McGuire Unit 1 Cycle 12
Core Operating Limits Report
July 1997

Duke Power Company

McGuire 1 Cycle 12 Core Operating Limits Report

IMPLEMENTATION INSTRUCTIONS FOR REVISION 14

Figure 5

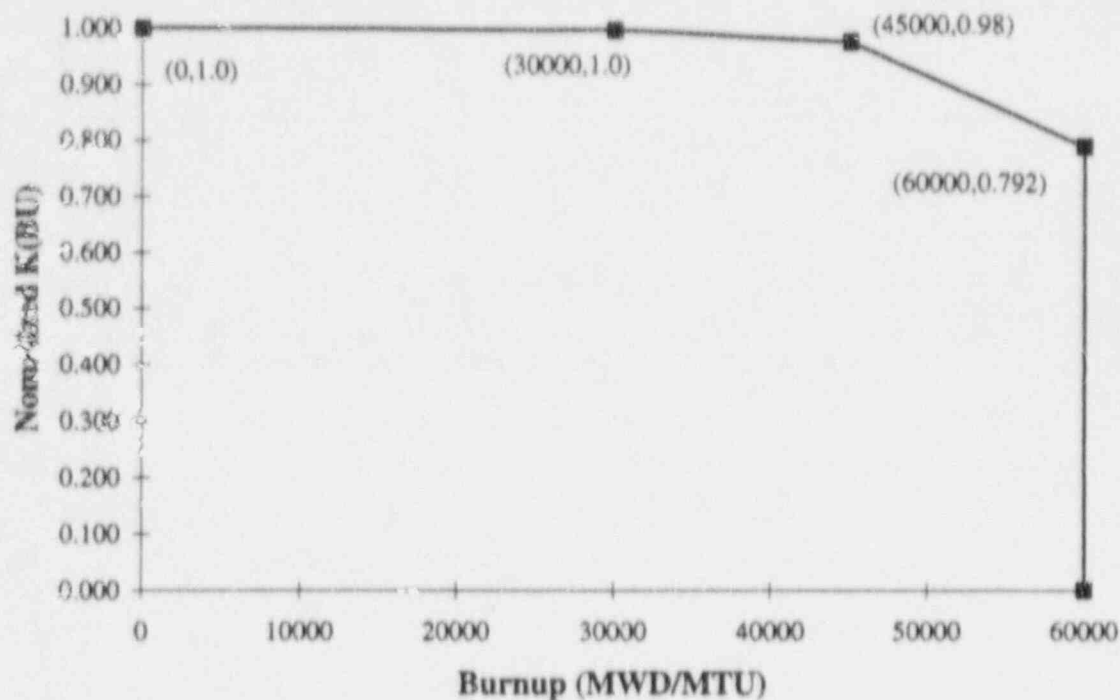
Revision 14 to the McGuire Unit 1 COLR contains changes to the F_Q K(BU) curve in Figure 5 and changes to the Appendix. As noted on page 21, the information contained in the Appendix is not transmitted to the station. However, this information is provided to the NRC.
